Rebuttal Report for

Michael L. Deas, P.E., Ph.D

Figure 1. Comparison of simulated Millerton Reservoir profiles for a 1 meter layer thickness (“Orig”) and a 0.5 meter layer thickness (“Refine”)

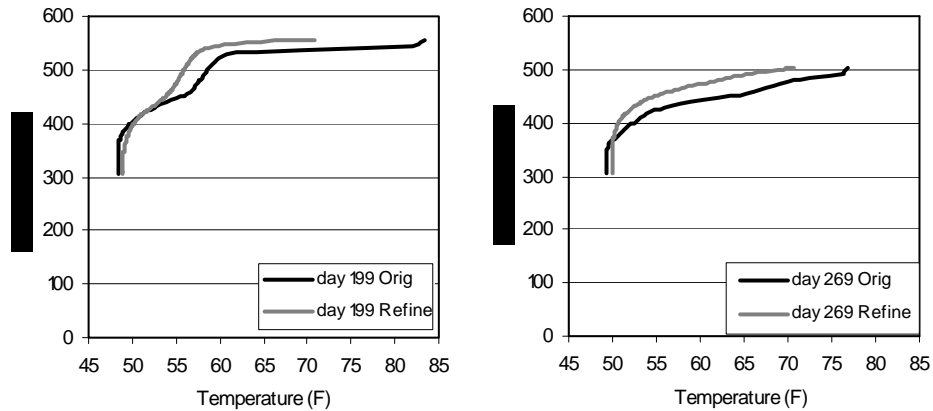
In addition to these identified uncertainties, no discussion of the effect of model spatial resolution is presented. Specifically, no testing of the segment length or layer thickness is presented - the process of incrementally refining the model grid (reducing layer thickness, reducing segment length) while holding all other parameters and conditions constant. Informal testing of the model indicates that reduction in layer thickness from

1.0 meter to 0.5 meters resulted in different simulated profile temperatures (Figure 1). These results are not intended to denote improvement in existing model performance under the refined grid – a recalibration would need to be completed – but that refinement may improve representation of the thermal regime. Although not completed as part of this rebuttal report, refinement of the segment length (longitudinal resolution) is also recommended. These refinements have not been completed due to time constraints.
